# Intel<sup>®</sup> Desktop Board D975XBX2 Specification Update

July 2008

Order Number: D74278-003US

# Specification Update for the Intel® Desktop Board D975XBX2

**Figure 4. Dual Channel (Interleaved) Mode Configuration with Two DIMMs**

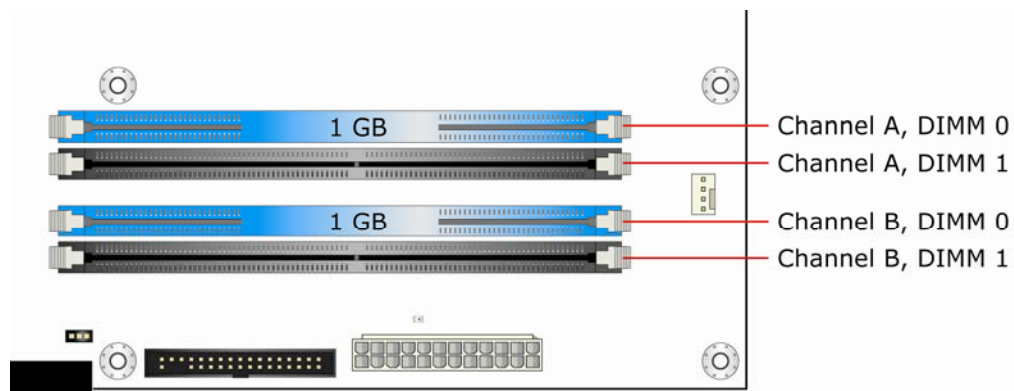
No.	Plans	Specification Changes
1	Doc	Change to Section 1.4.1.1 to add Channel B in Figures 4 and 5.
No.	Plans	Errata
		There are no characterized erratum for this product.

1. Figures 4 and 5 of Section 1.4.1.1 of the Technical Specification will be updated to include both Channels A and B in the Dual Channel (Interleaved) Mode Configurations.

Figure 4 shows a dual channel configuration using two DIMMs. In this example, the DIMM0 (blue) sockets of both channels are populated with identical DIMMs.
